Modification Report

MOD 1 – SSD-15788005

New Education Campus at Jindabyne
(New Primary and High School)

17 November 2022

Figure 2. Updates site plan mark-up
Source: Pedavoli architects modified by Mecone

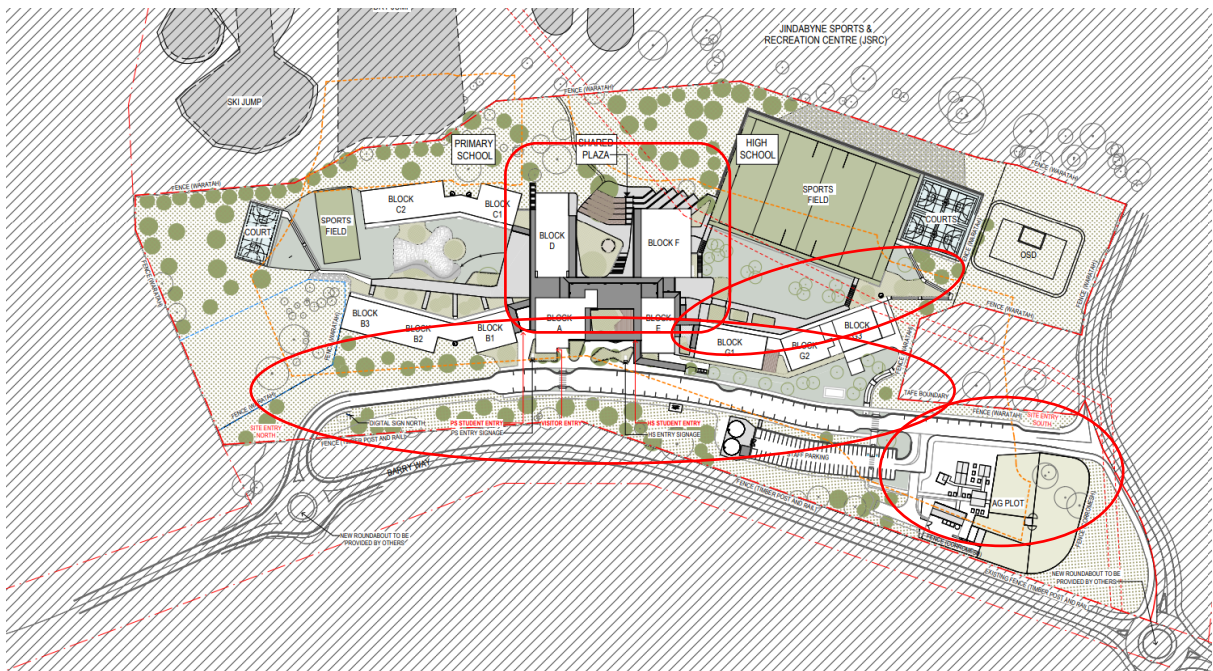
The key changes are identified in the site plan mark-up below and discussed in further detail in the following sub-sections.

Figure 4. Proposed ground floor plan of Block G
Source: Pedavoli architects

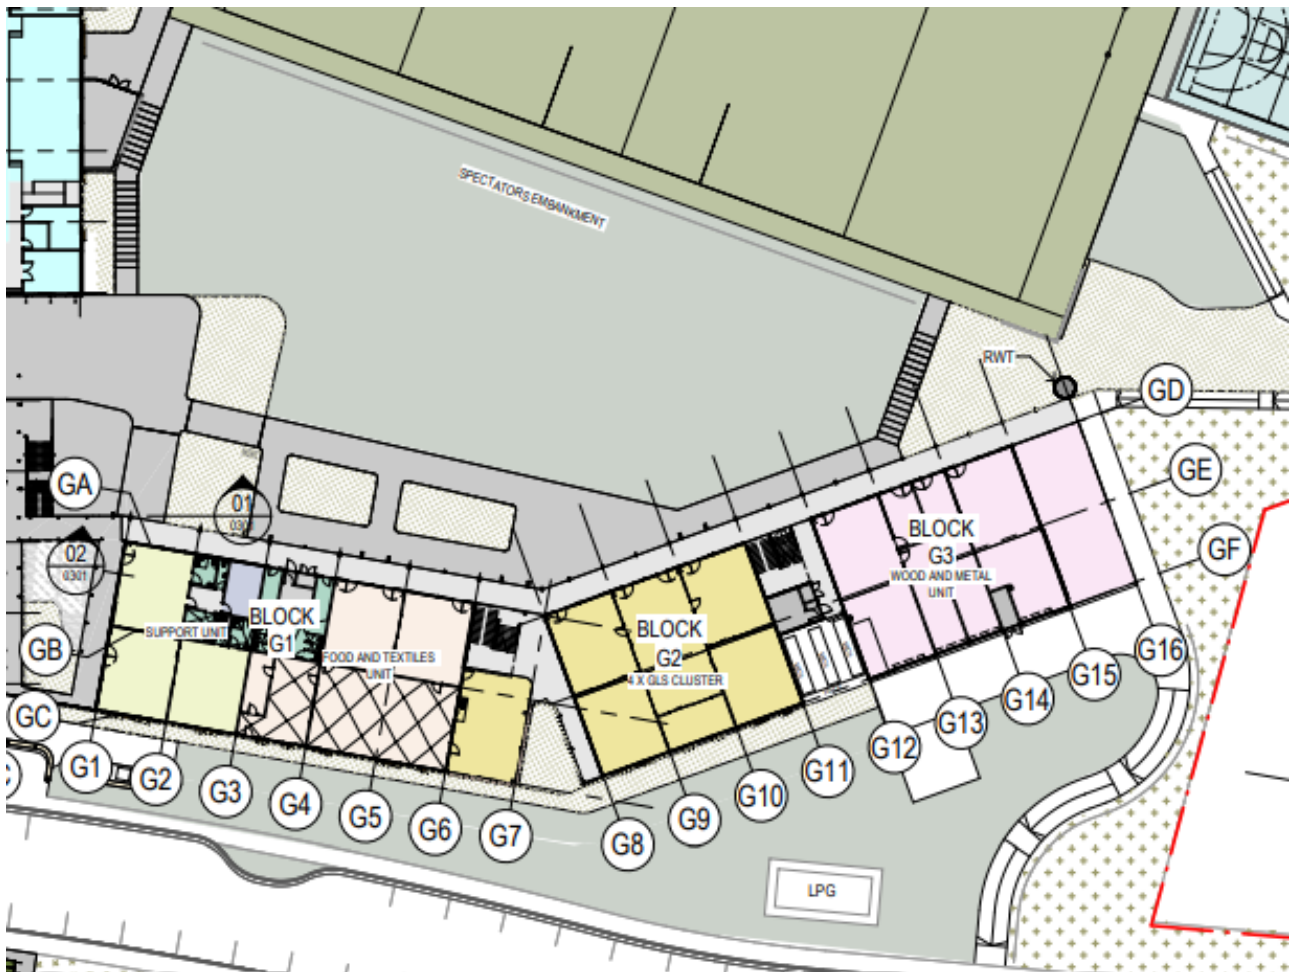
In the approved design Building G consisted of two blocks—G1 and G2—with Block G2 containing the wood technology rooms with an outdoor space. Four additional GLS classrooms have been provided to Block G2 with minor

amendments to the internal layout. A new Block G3 now proposes to contain the wood technology rooms with the outdoor space.

Figure 6. Proposed site plan showing access changes
Source: Pedavoli architects

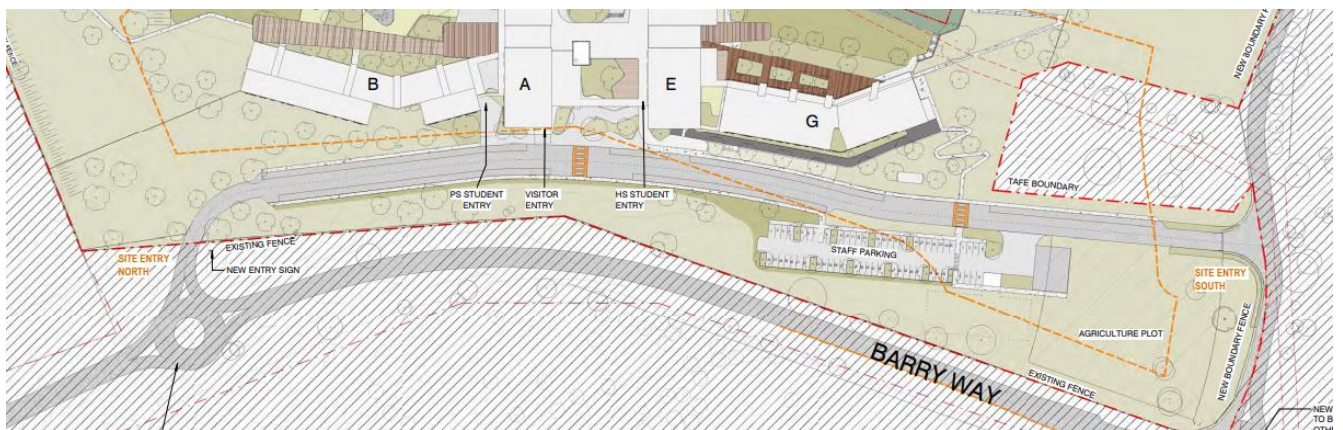
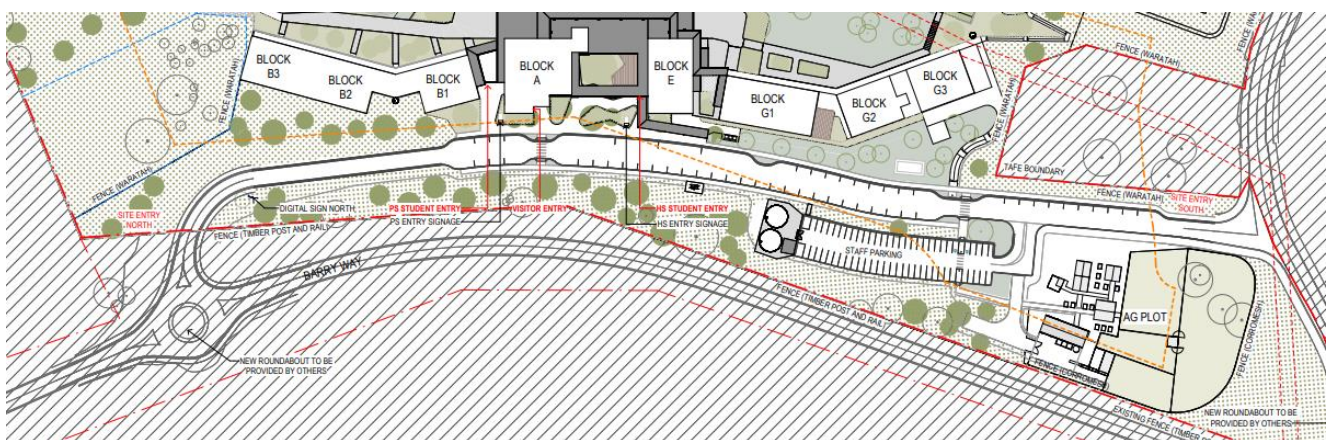
- Modifications to the internal road works to better align with the off-site works, including the two roundabouts to Barry Way.
- DOPU spaces moved to the southern two-thirds of internal school road, closer to the campus pedestrian entry points, providing for better access to the main entry points.
- Regrading of the internal school road to provide more accessible gradients.
- Minor realignment of the car parking area to better relate to the access road for pedestrian accessibility from car park to main entrance and minimise earthworks.
- Widening of bus bays from 2.6m to 3m wide to comply with Australian Standards.

- One additional DOPU space in the internal school road (total DOPU spaces increased from 53 to 54).
- Four visitor spaces moved from the internal school road to car park (car park total spaces increased from 56 to 60).

Figure 8. Proposed finished floor levels
Source: Northrop

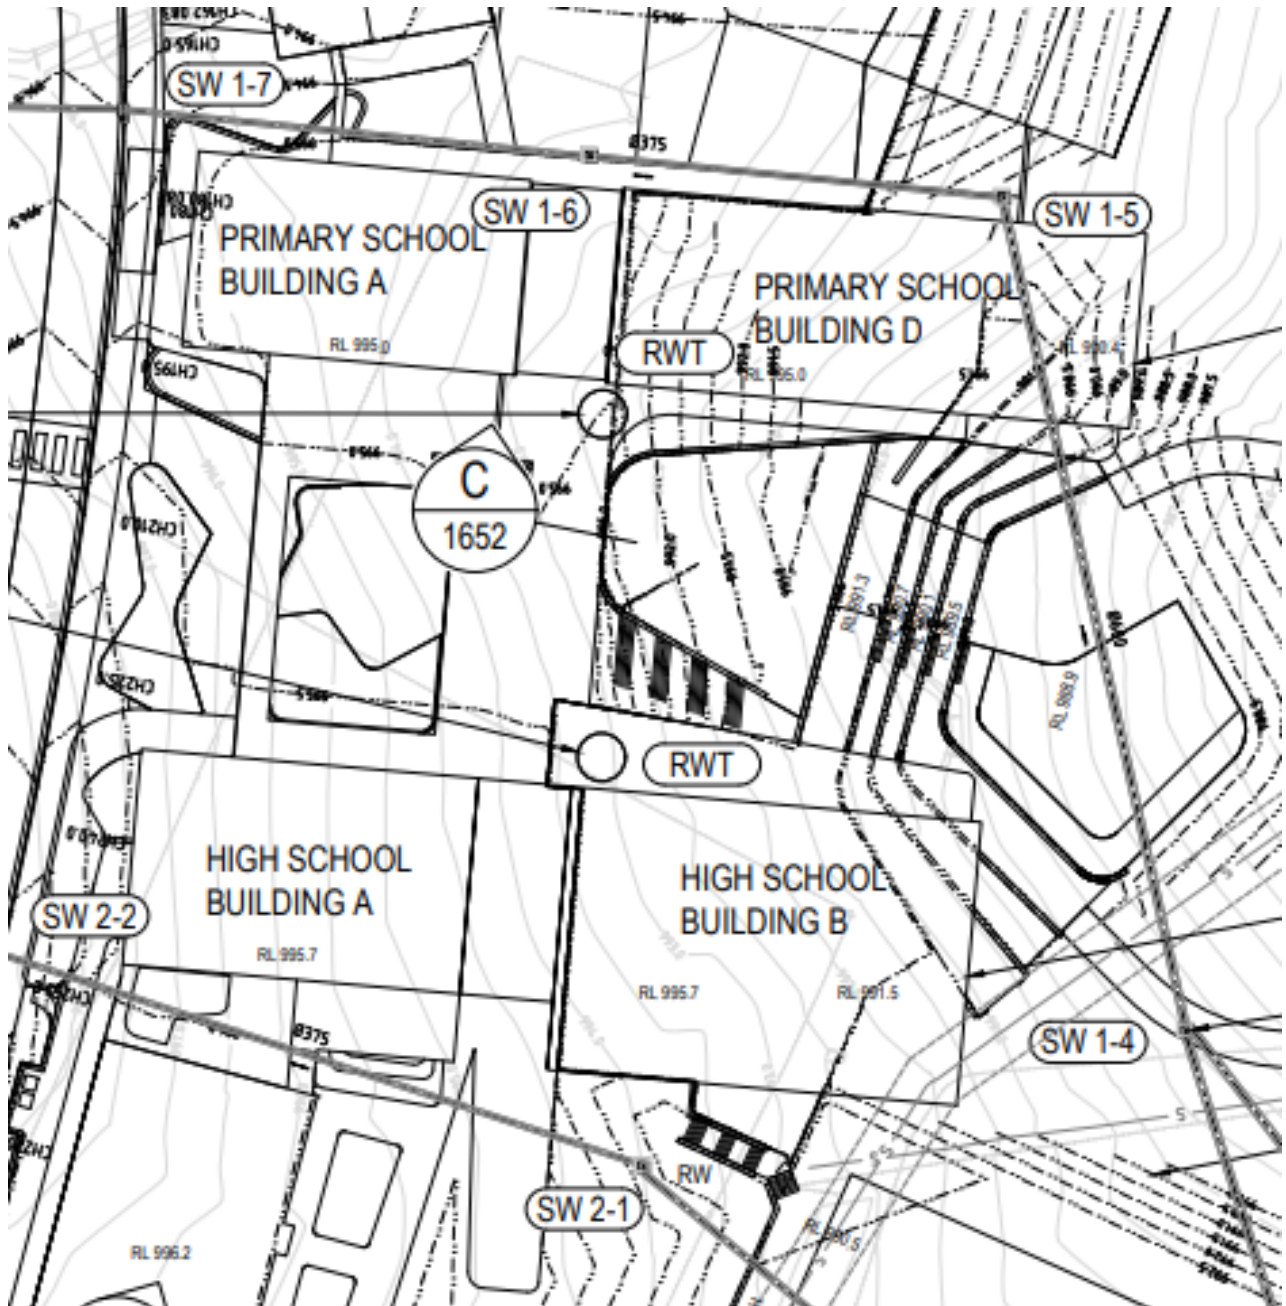
The floor levels of buildings have been modified slightly to better align with the revised internal road levels. The four central buildings—A, D, E and F—now have the same RL to improve accessibility across the site.

This results in the floor levels of the southern buildings—A and E—rising by 350mm from +995.00 to +995.35, and the northern buildings—D and F—lowering by 350mm from +995.70 to +995.35. The associated ground levels have been modified to suit.

Figure 10. Proposed roof plans Block G
Source: Pedavoli architects

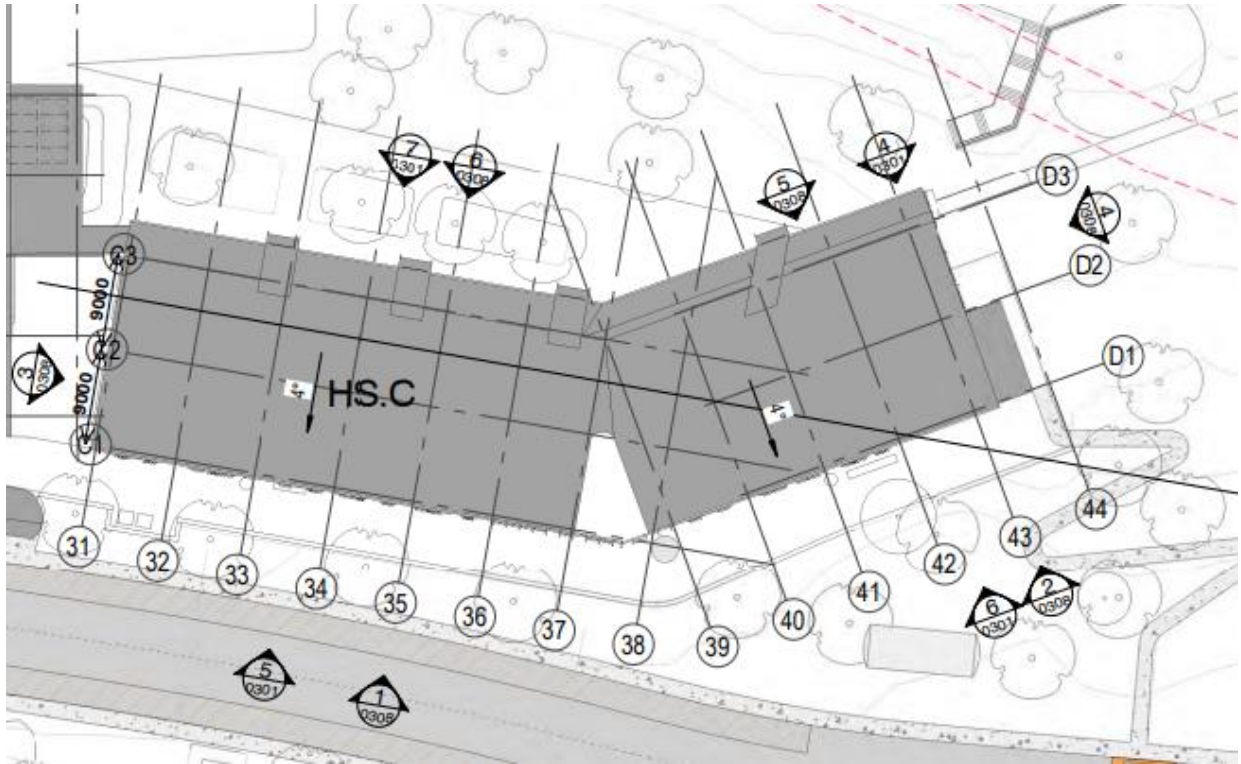
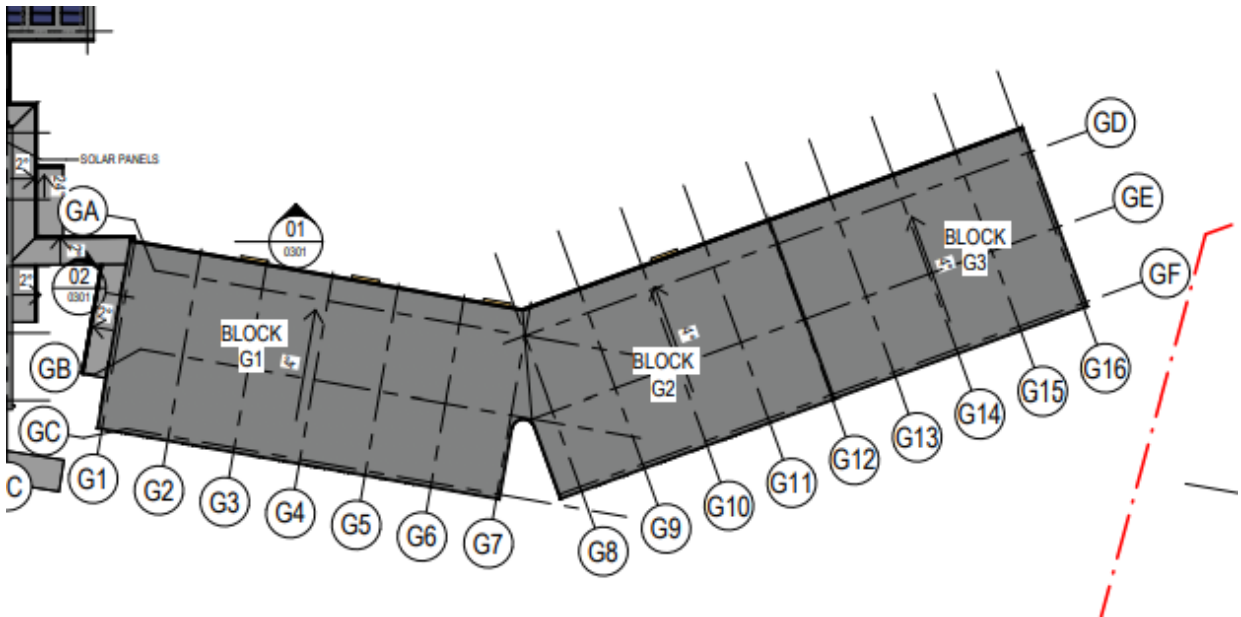
Buildings G1, G2 and G3 now have a single pitch falling towards the internal portion of the site. All downpipes are located on the internal face, providing a neat presentation towards Barry Way and school frontage. The central courtyard roofs have been redesigned to add fall to allow drainage. The north-south link is repositioned to the east to allow the roof pitch of these roofs to be resolved.

Figure 12. Proposed roof plan Buildings A, D, E & F

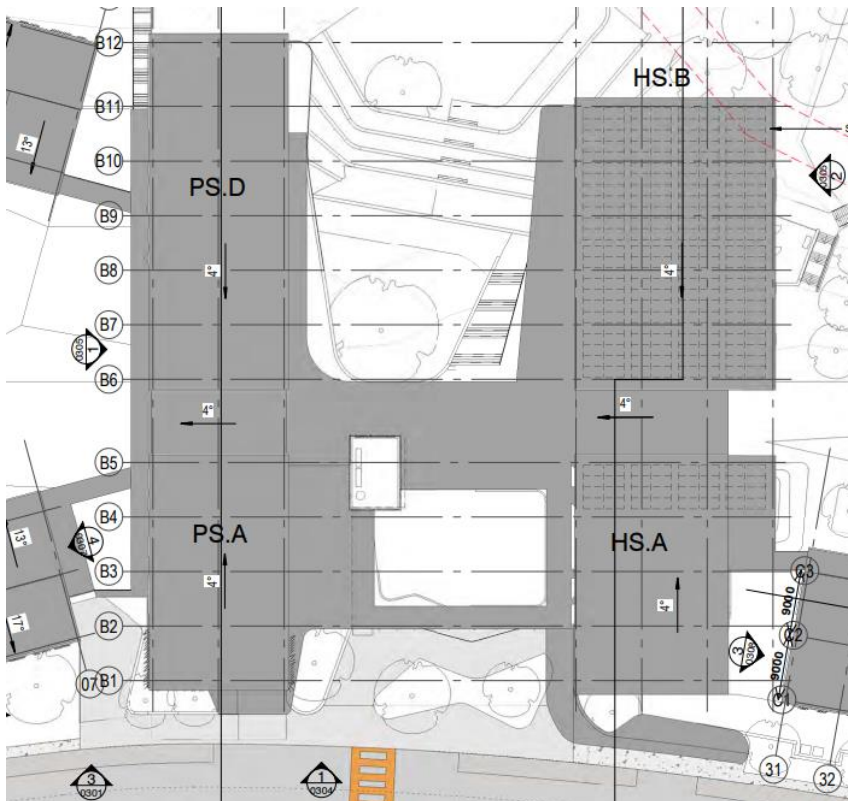
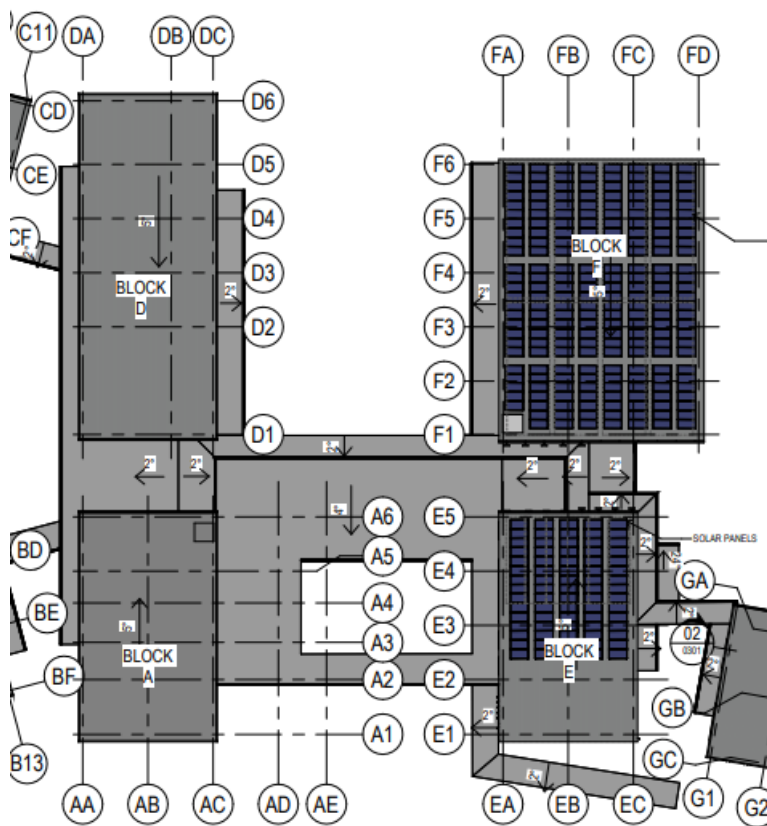
The roof pitch of Buildings A, D, E and F has been increased slightly, from a 4% fall to 5% fall east and west, and decreased from 4% to 2% north and south at the centre of the buildings. This has been done in order to improve drainage outcomes.

Figure 18. Proposed Agricultural Plot layout
Source: Pedavoli architects

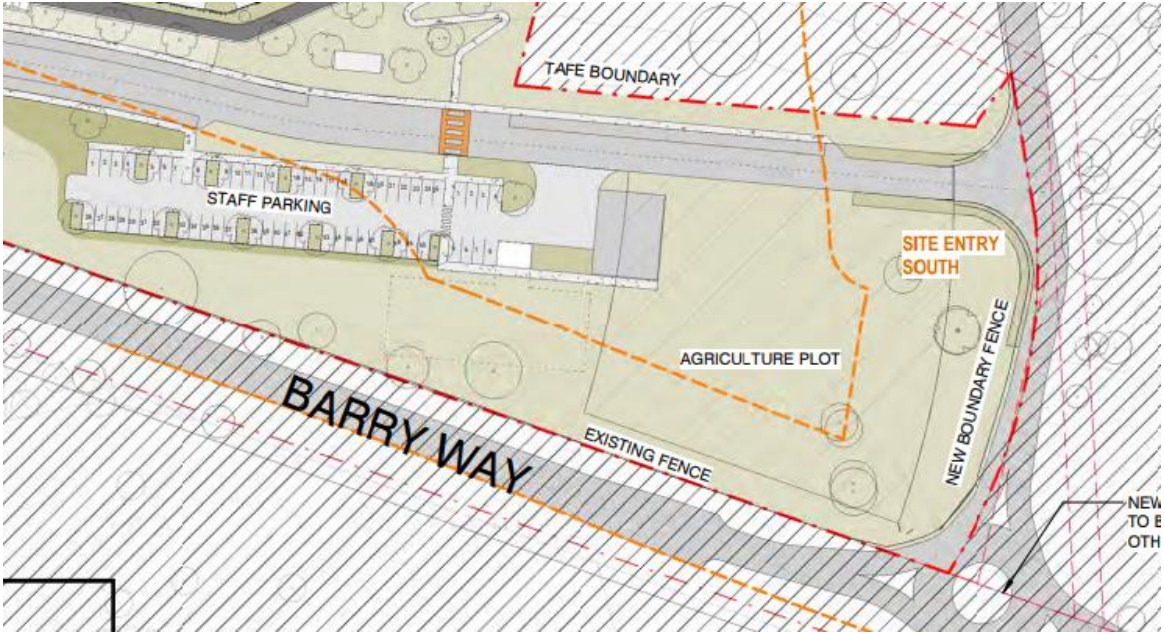
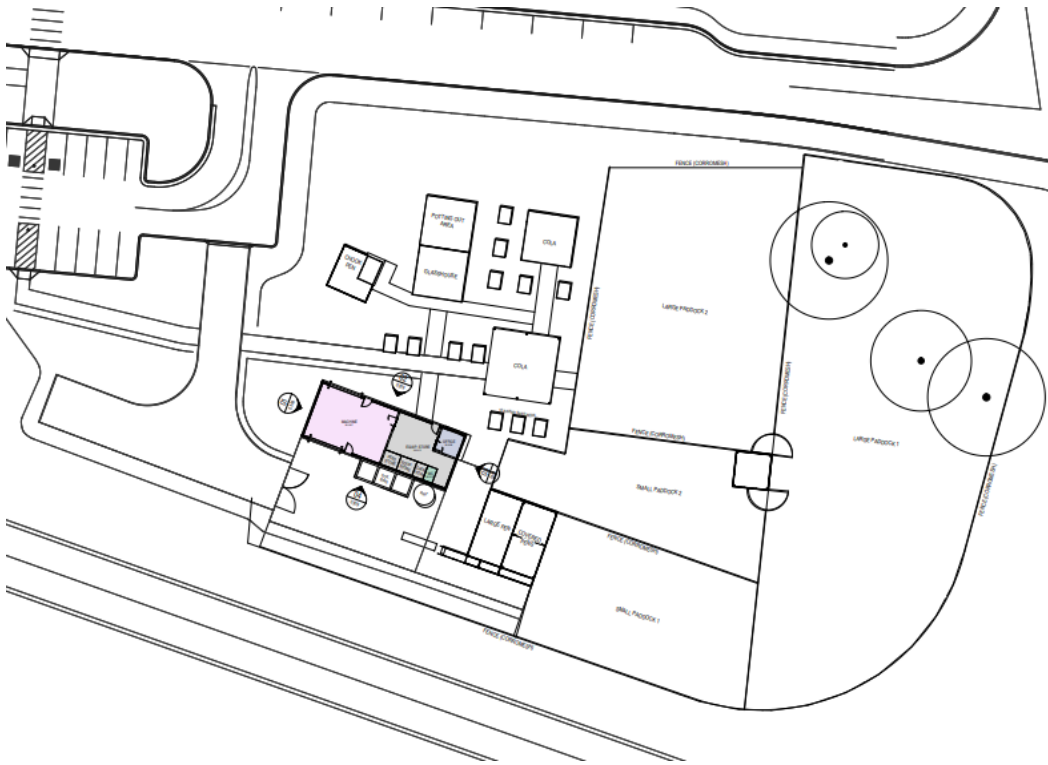
Design development of Agriculture Plot has resulted in the inclusion of new buildings and structures and modification of levels.

The Agricultural Plot proposes to include a building for the storage of machine and equipment including amenities and an office, rainwater tank, chook pen, potting out area, glass house, 2 covered outdoor learning areas, 12 raised seed beds, large pen, covered pens, 2 small paddocks, 2 large paddocks and associated access paths.

Figure 21. Asset protection zone showing Agricultural Plot
 Source: Blackash

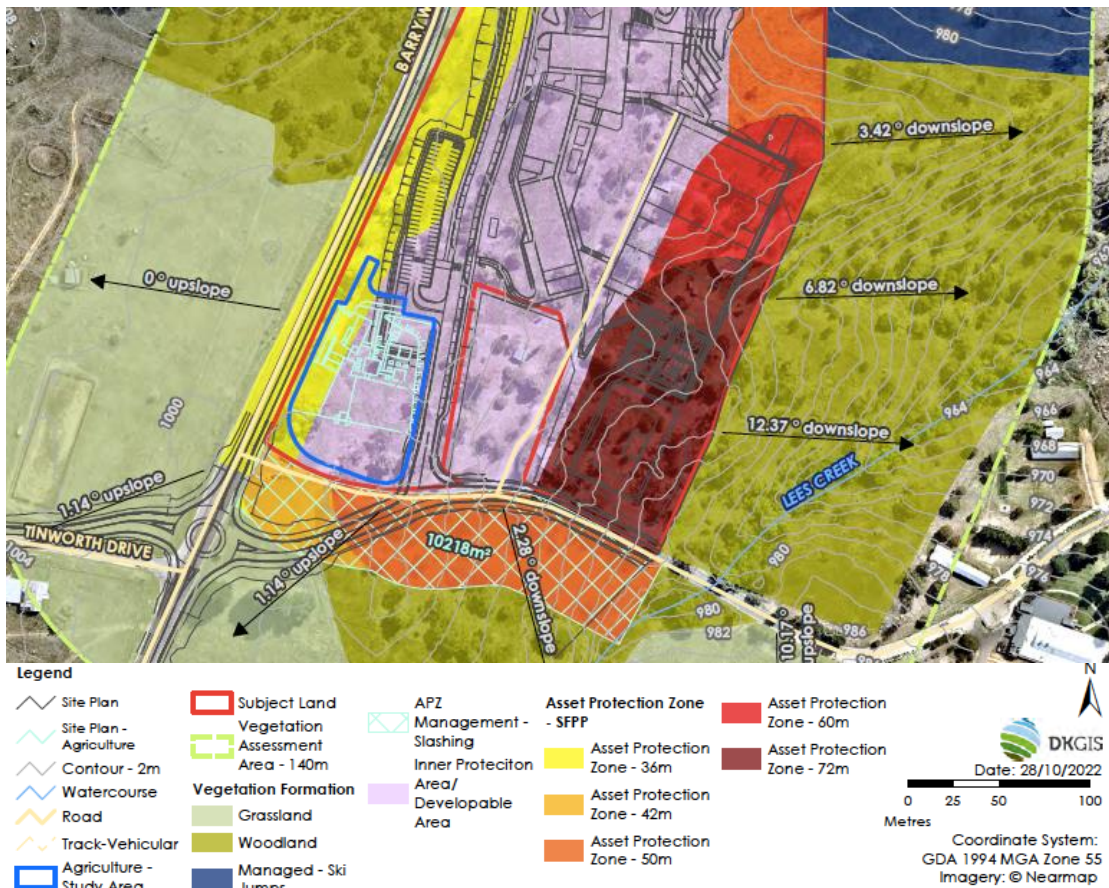
The proposed Agricultural Plot buildings do not have any classrooms, and the structures are designated as "other" development under Planning for Bushfire Protection (PBP). While part of the Agricultural Plot machinery store (approximately 2m) is within the identified Special Fire Protection Purpose Asst Protection Zone (APZ), when treated as "other" development as per PBP, it meets BAL 12.5 for the vegetation type and slope. This is in line with the remainder of the school and affords basic ember protection to the machinery shed.
